Petition Number: 2019-036 General Location Identifier: 05301131

From: Felix Obregon, PE Reviewer: Molly T Haynes, PE

Date	Description
04-15-2019	First Review
08-15-2019	Second Review

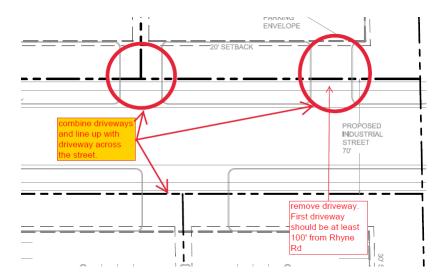
- 6. The petitioner should revise the site plan to eliminate the driveway shown below to reduce vehicular conflict points.
 - a. The petitioner should revise the site plan to combine the driveways and line them up adjacent from one another along the Proposed Industrial Street to eliminate multiple conflict points.
